April 13, 2022

**RE: Green Ridge Recycling and Disposal Facility, LLC
Supplement to Response TR-1 (October 1, 2021)
Notice of Intent and Part A Application - SWP 626
DAA Job Number: 18020117-090102**

Listed below are DEQ comments #11, #14, #15, and #16 (in italics), followed by our corresponding response.

UPDATED BORING PLAN SUPPLEMENTAL
BORING LOCATIONS

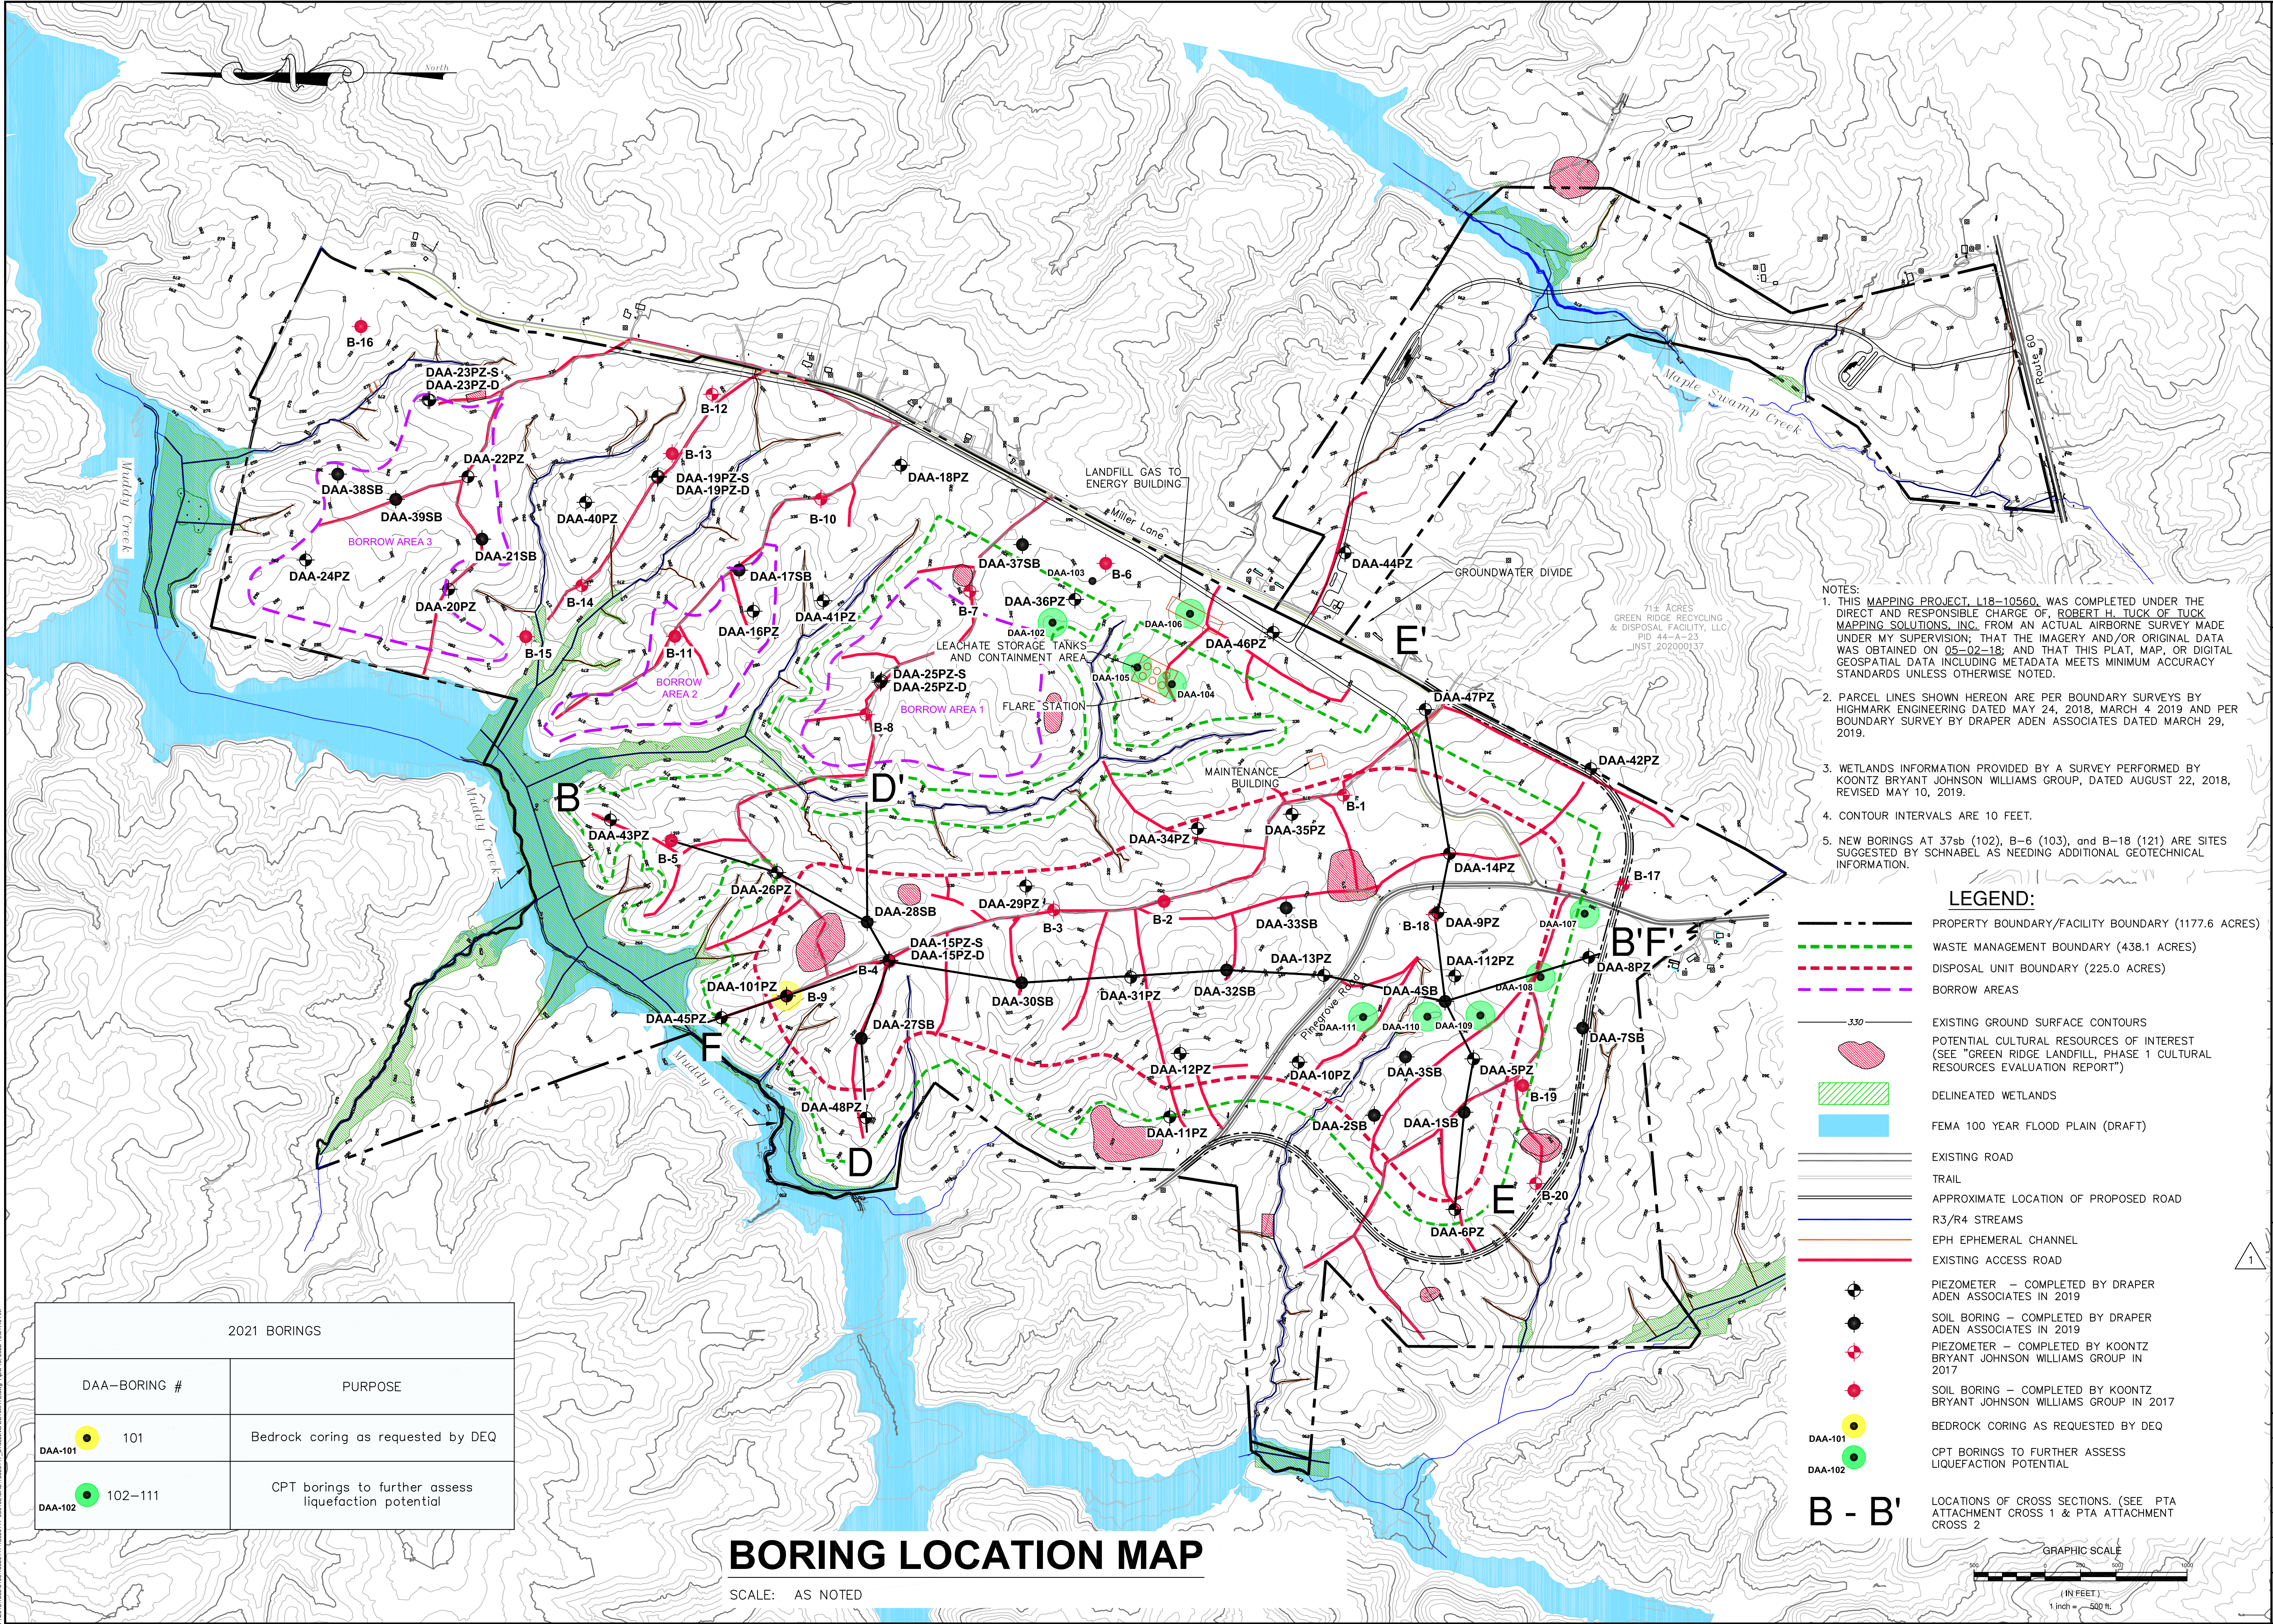
DEQ Comment #11: *The proposed base grades depicted in Attachment XV of the Part A Permit Application show the base grades constructed 10 to 25 feet into the bedrock in some areas (e.g., South of B-5, and near DAA-27sb). However, it appears that none of the borings performed for the Part A Permit Application were installed more than 10 feet into bedrock at the site. In accordance with 9 VAC 20-81-460.E.1.e., at least one deep boring should be installed into bedrock where the deepest base grades are proposed. The bedrock should be cored continuously for the first 20 feet below the proposed base grade. This will provide necessary information in accordance with 9 VAC 20-81-120.D.1 regarding the rate and direction of groundwater flow in the bedrock, ability to monitor groundwater in bedrock, the need for blasting or adjustment of base grades, potential hydraulic inter-connection with other regional groundwater wells, etc.*

Attachment 1 contains a drawing entitled PTA ATTACHMENT XII - FIGURE: BOR - Revision 1 - "Supplemental Boring Locations," dated 04/12/2022 as prepared by Draper Aden Associates, is a 1 inch = 500 feet scale plan view showing the Facility boundary, waste management boundary (WMB), disposal unit boundary (DUB) and additional boring/piezometer locations. *This figure replaces PTA ATTACHMENT XII - FIGURE: BOR, dated 12/9/2019 submitted with the initial Part A application.*

On November 30, 2021, DAA supervised the drilling and installation of a deep boring/piezometer DAA-101pz. As proposed in the October 1, 2021 technical review response letter and shown on **Attachment 1**, DAA-101pz was installed at the northern section of the disposal cell, adjacent to existing soil boring B-9. The north section of the disposal cell is where the deepest conceptual base grades were proposed. DAA-101pz was advanced by Blue Ridge Drilling using hollow stem augers. Upon auger refusal at approximately 15 feet below ground surface (bgs), Wireline NQ2 rock coring equipment was used to core bedrock continuously from 15 feet to 55 feet bgs. Rock core samples were logged in the field and assigned a rock quality designation (RQD) value. Upon completion of rock coring activities, DAA-101pz was completed as a 2-inch diameter piezometer.
